Addendum No. 2
To the Plans and Specifications of

Mobile Fire Station #19
1309 Azalea Road
Mobile, Alabama 36693

Four Pages + Attachment(s)
June 26, 2025

M200
MECHANICAL PLAN

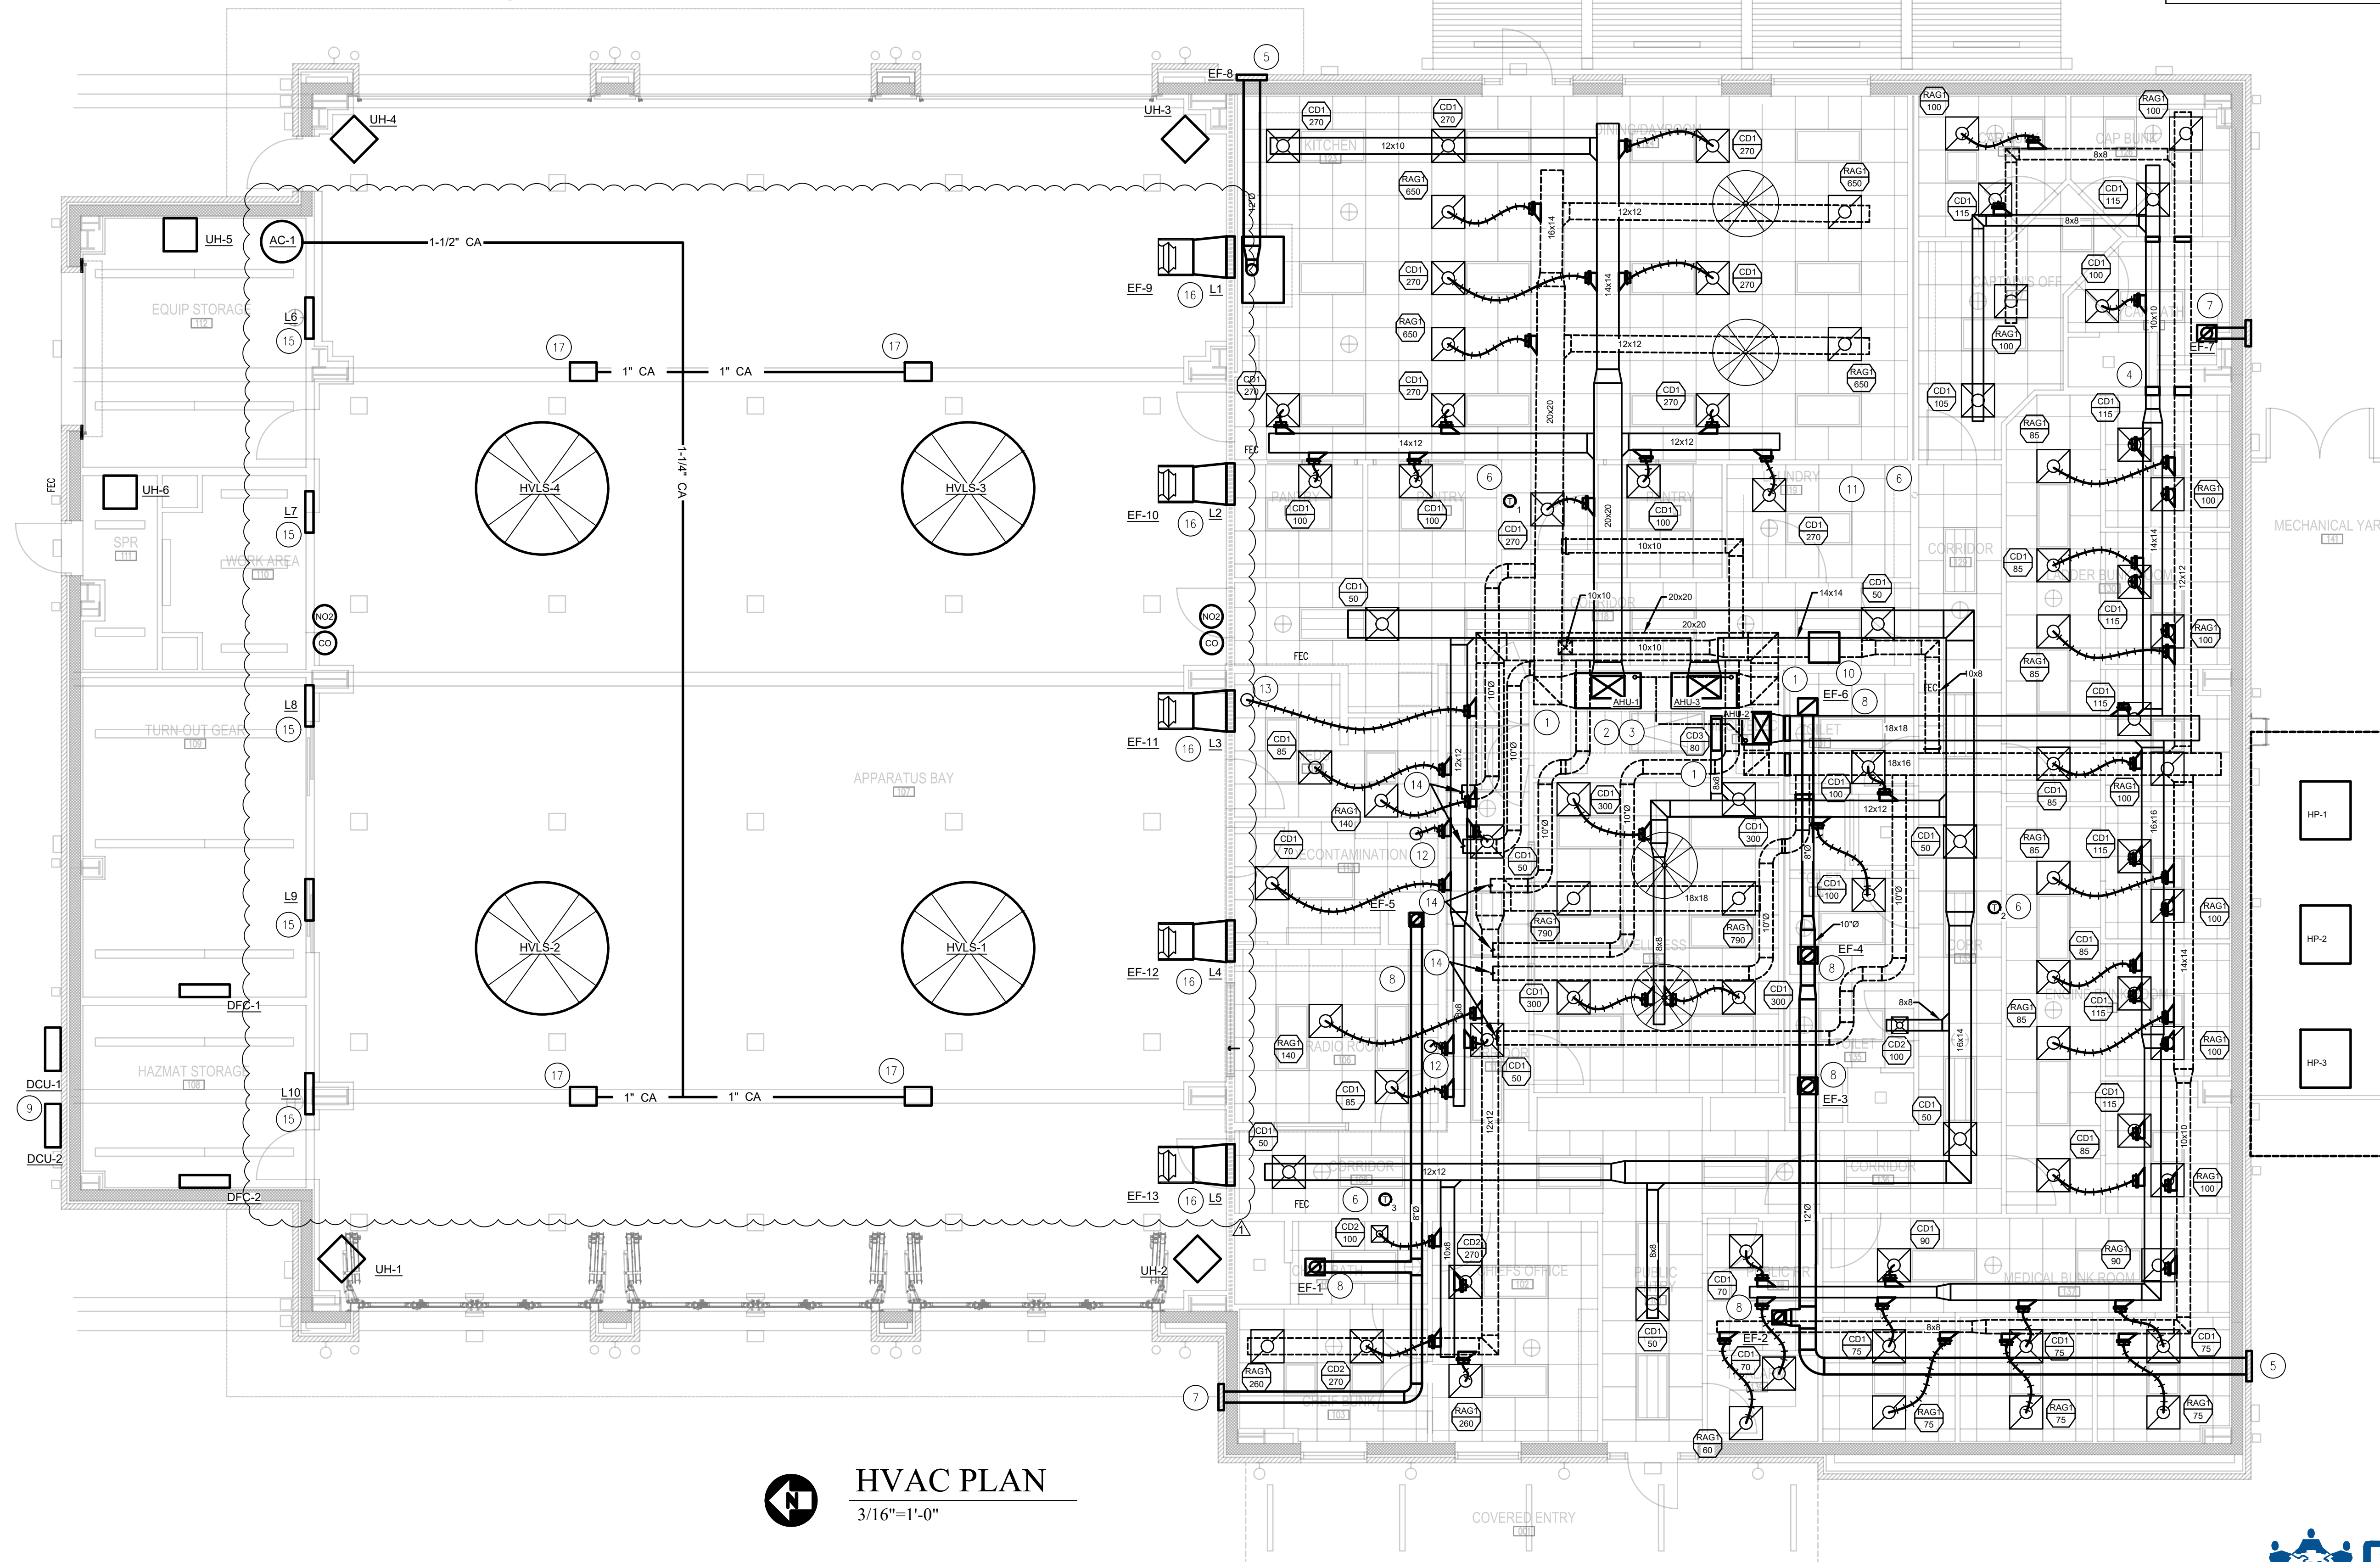
- M3. Sheet M200 – ADDED COMPRESSED AIR PIPING AND HOSE REELS. ADDED MOUNTING HEIGHTS FOR INTAKE LOUVERS AND EXHAUST LOUVERS/FANS. ADDED CO/NO2 SENSORS

P100

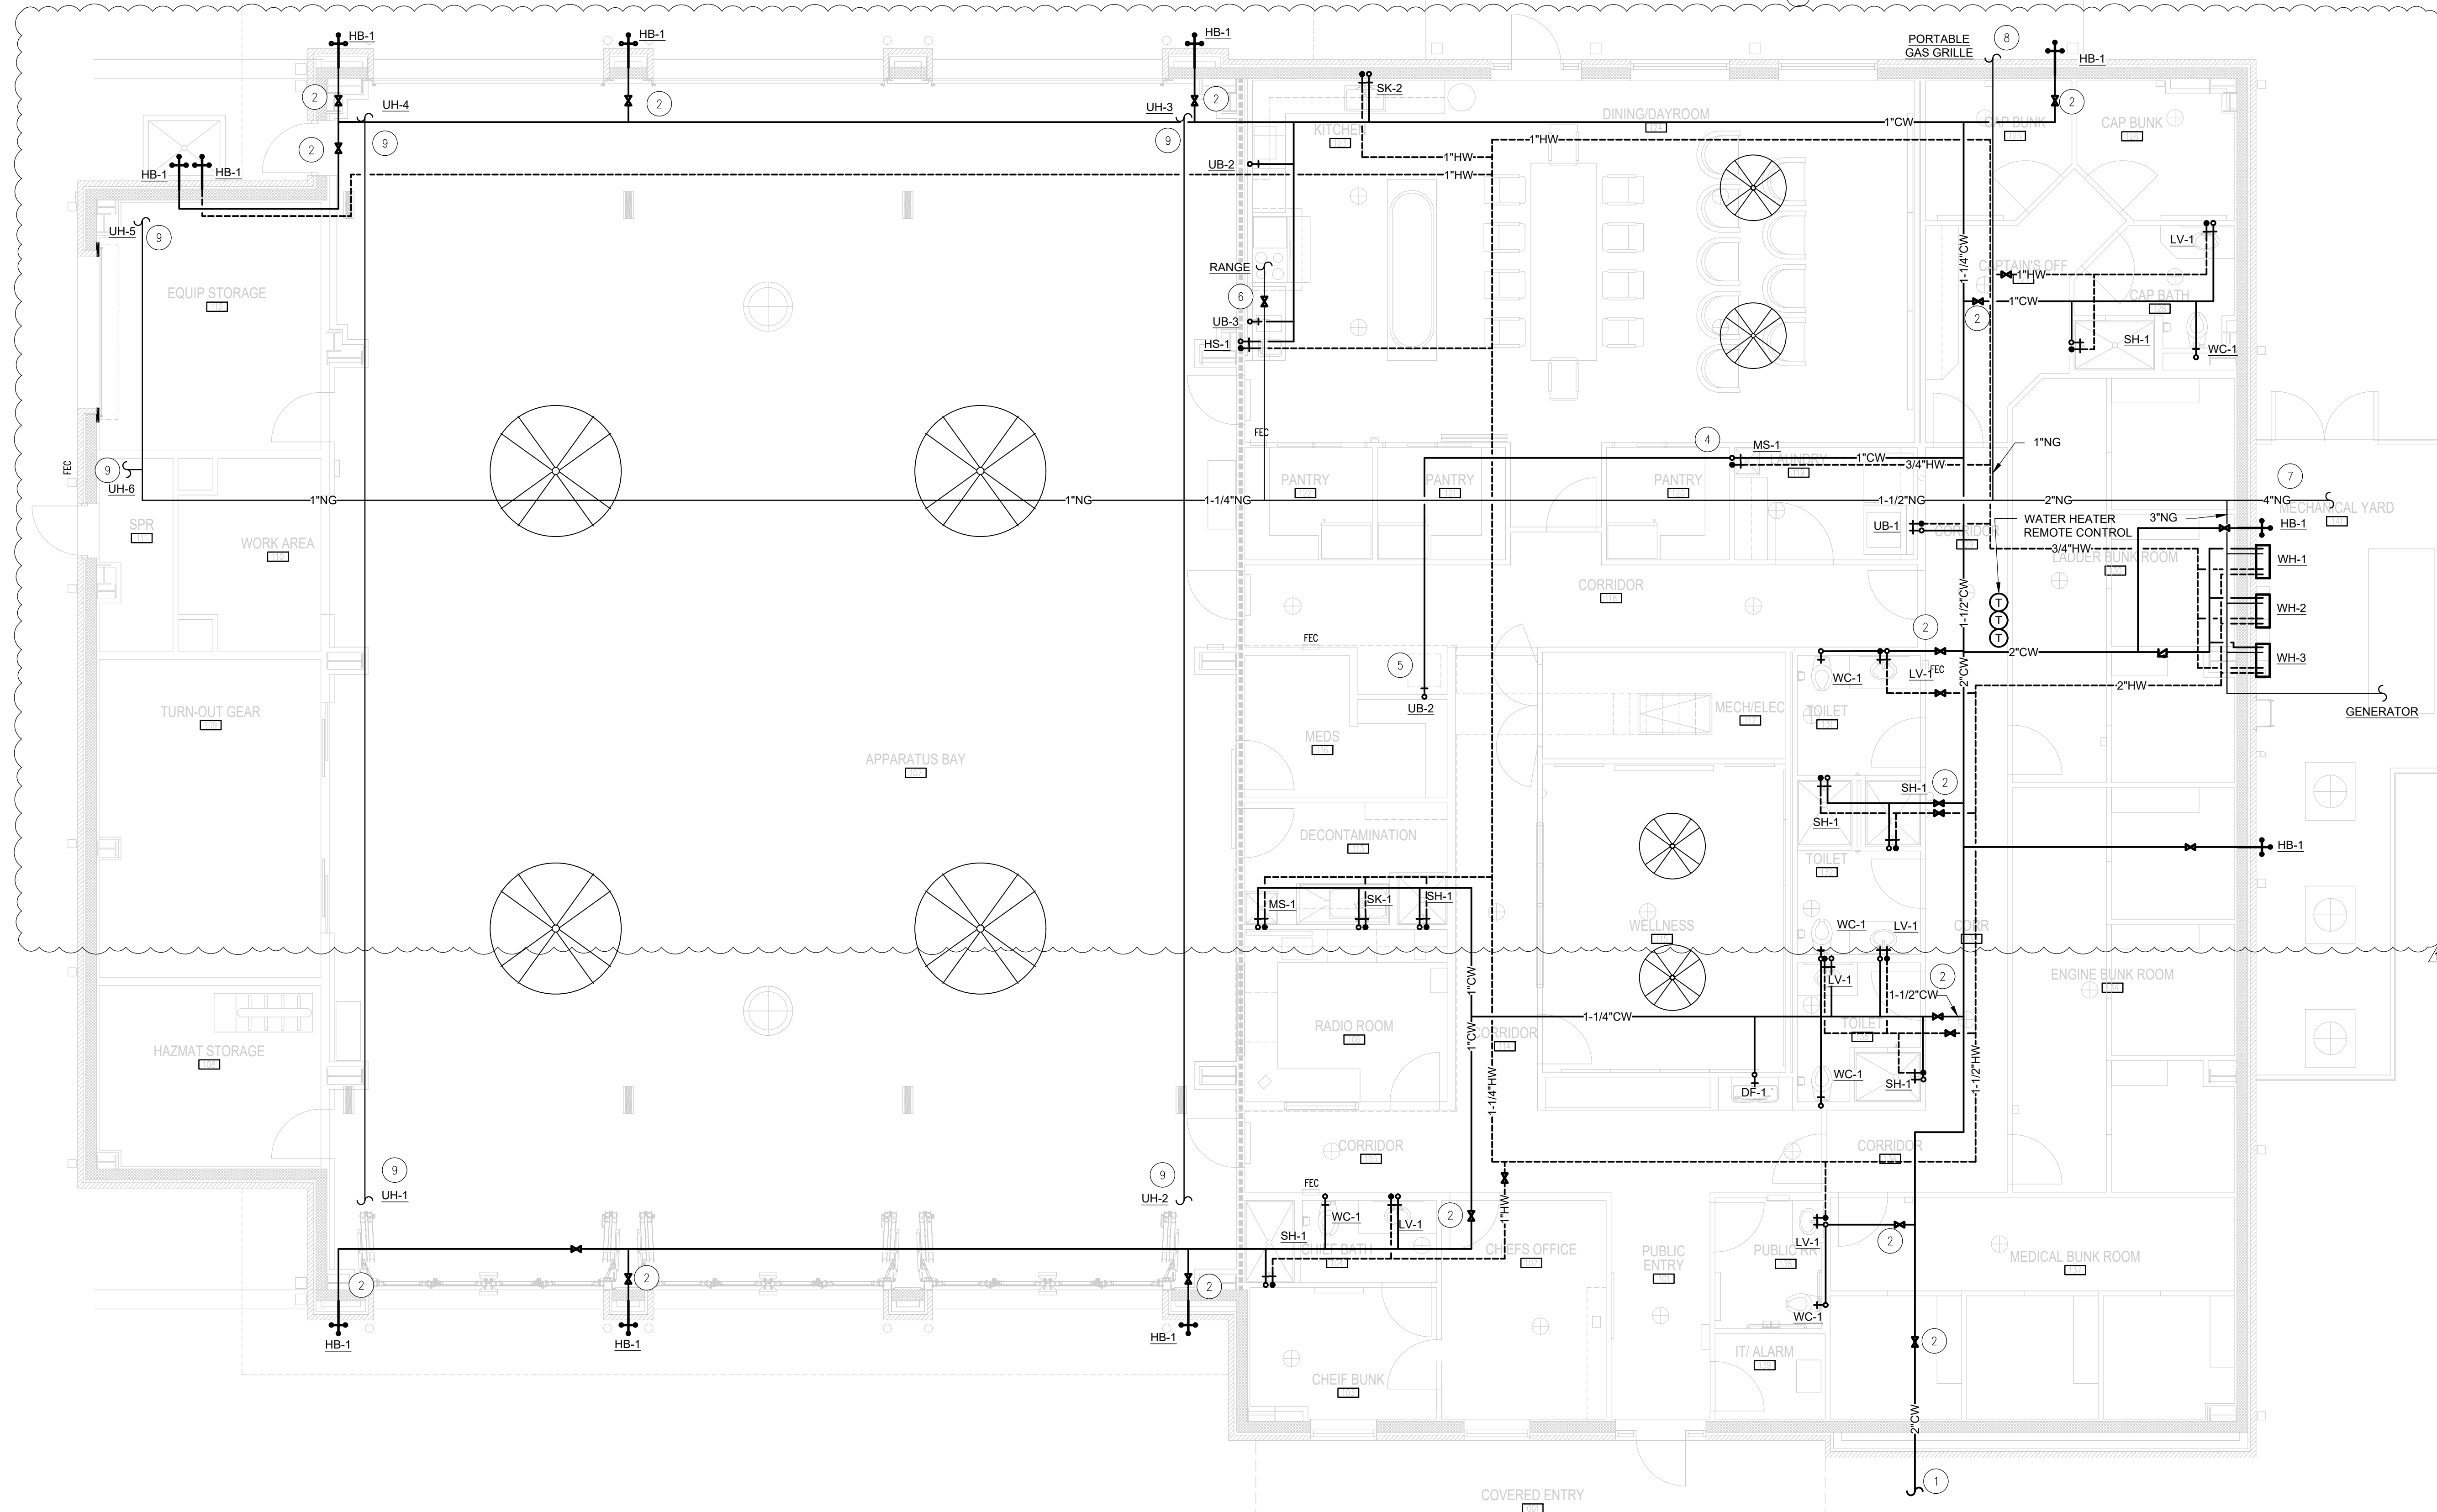
- M5. Sheet P100 – REMOVED TEST & BALANCE GENERAL NOTE SECTION. ADDED COFFEE MACHINE AND FLOOR SINK TO FIXTURE SCHEDULE. UPDATED PIPING SIZES FOR FLOOR DRAIN AND HOSE BIBB FIXTURES. ADDED ACCESSORY WATER HEATER REMOTE CONTROL TO WATER HEATER SCHEDULE.

P200
PLUMBING PLAN

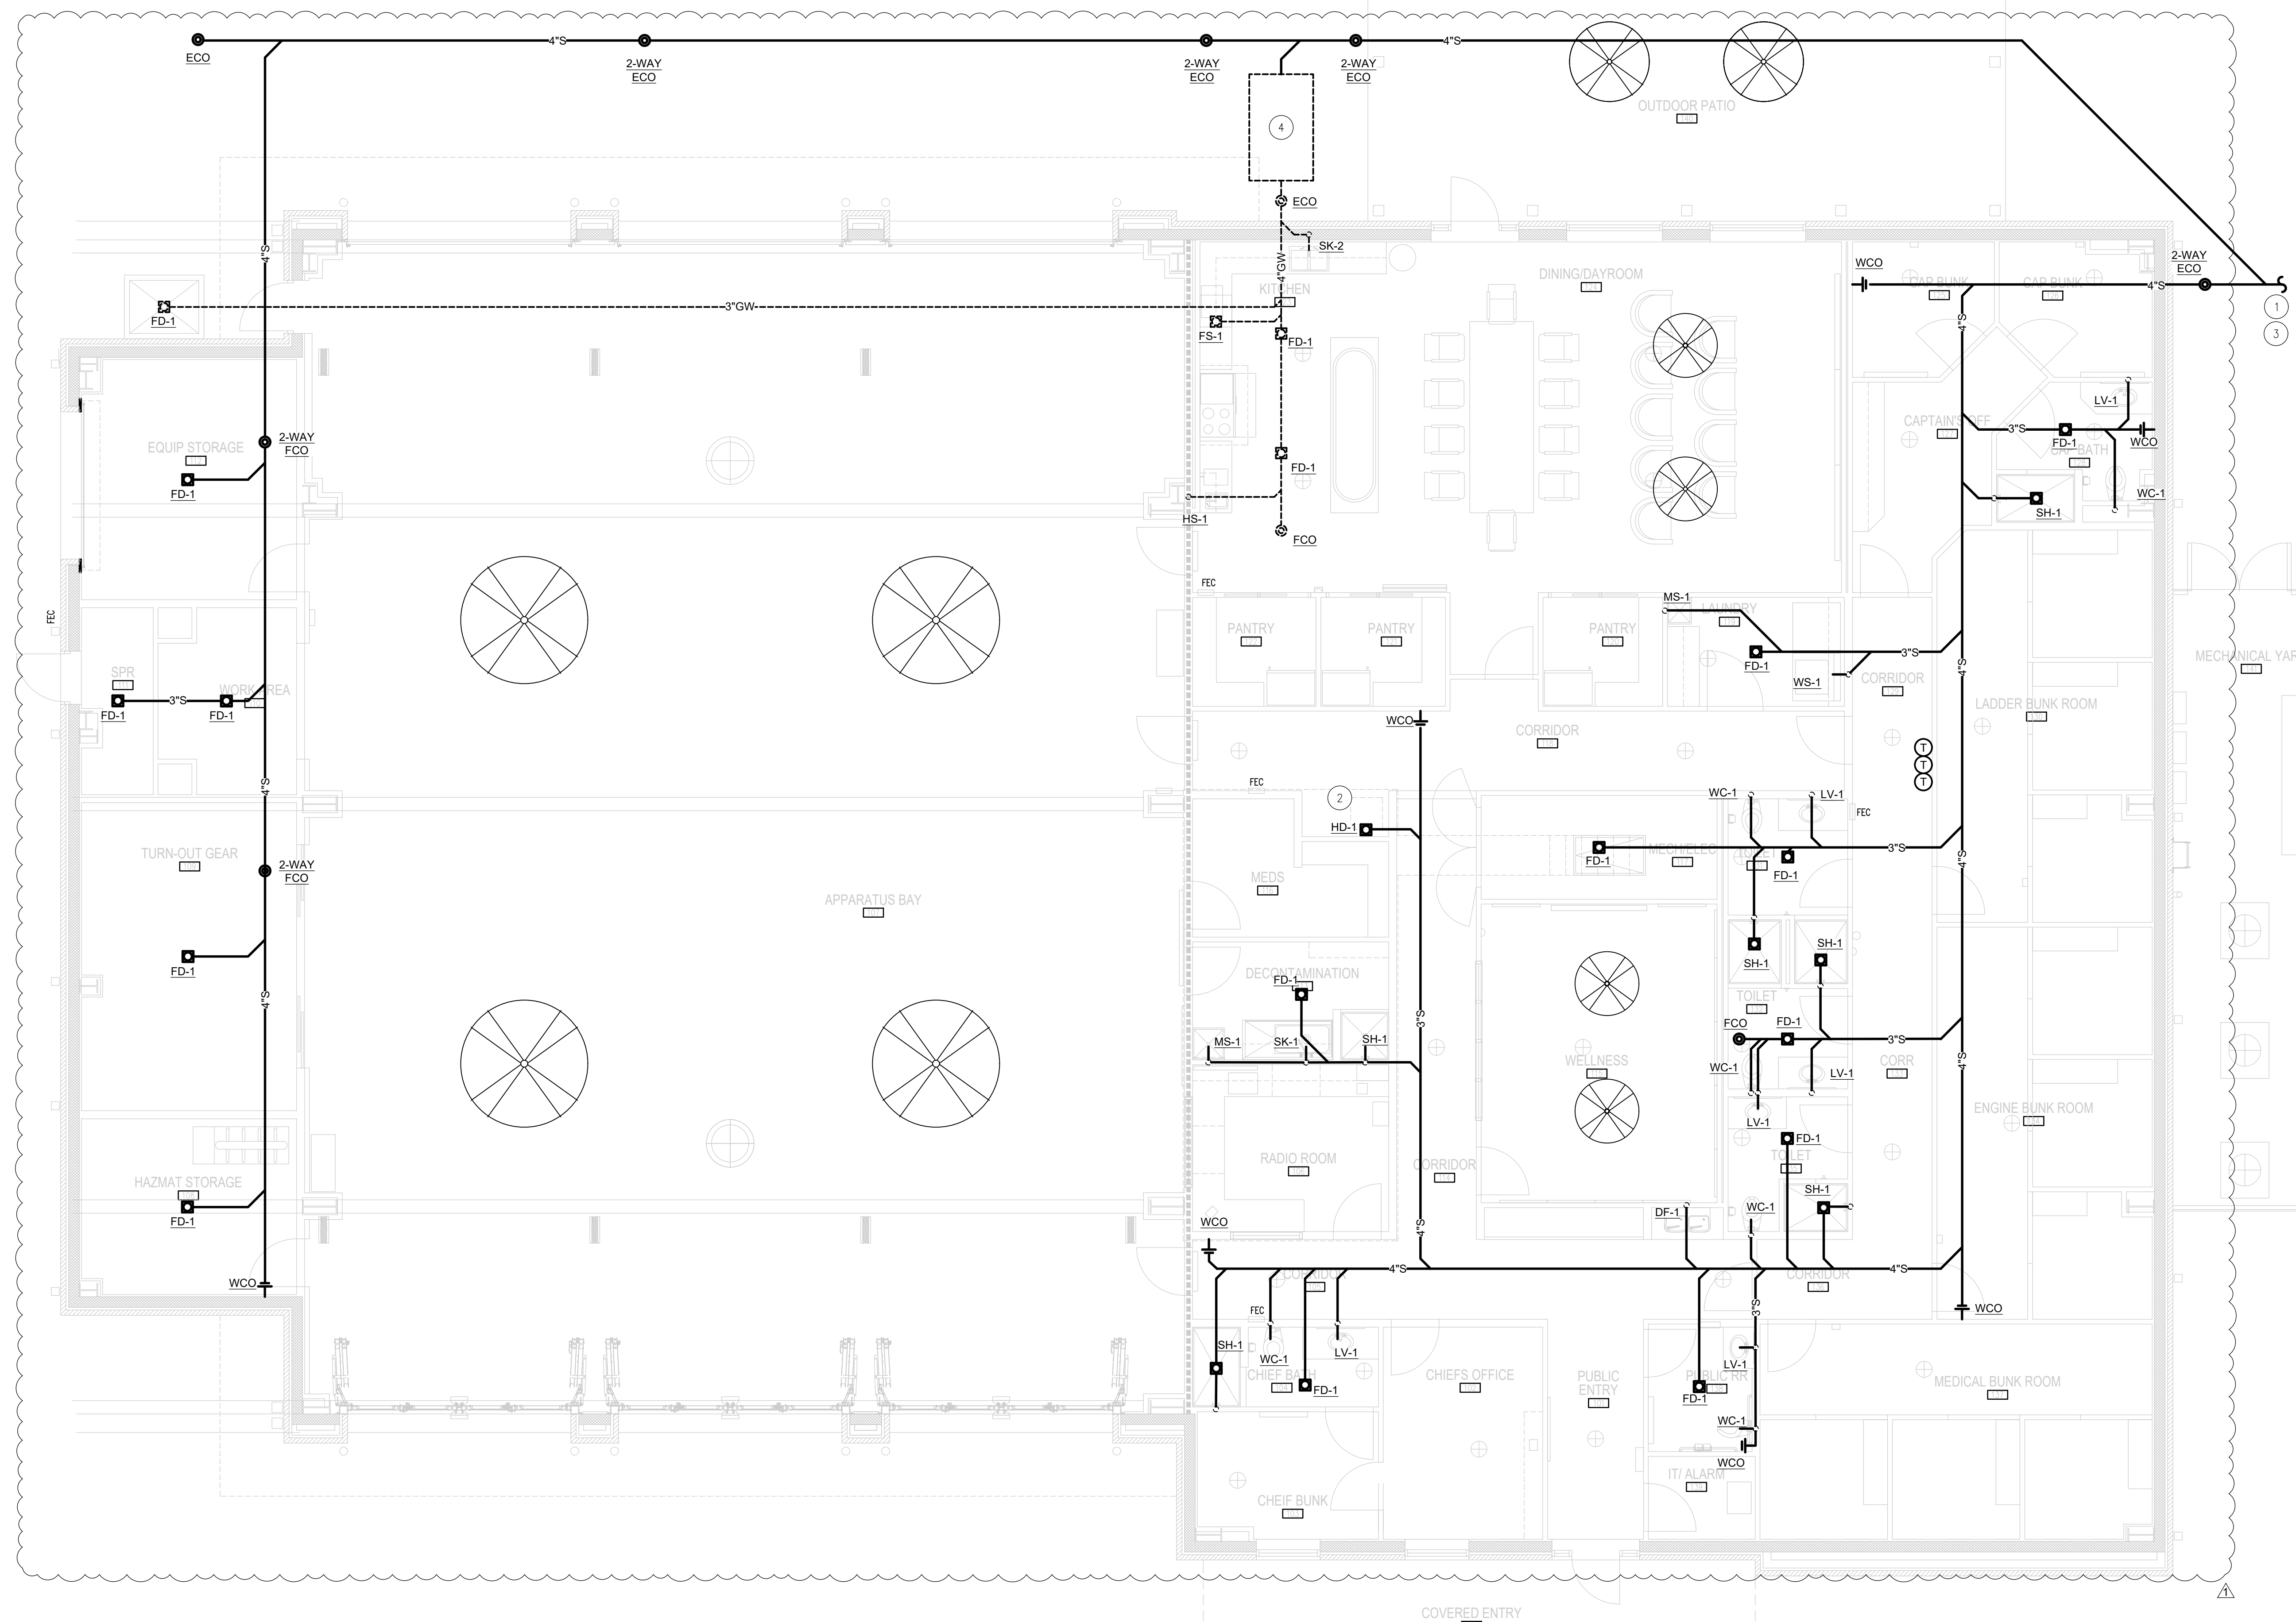
- M6. Sheet P200 – ADDED HOT WATER CONNECTION FOR CAN WASH. ADJUSTED NATURAL GAS PIPING SIZES. UPDATED KEYNOTE #2. ADDED WATER HEATER REMOTE CONTROL TO CORRIDOR 133.
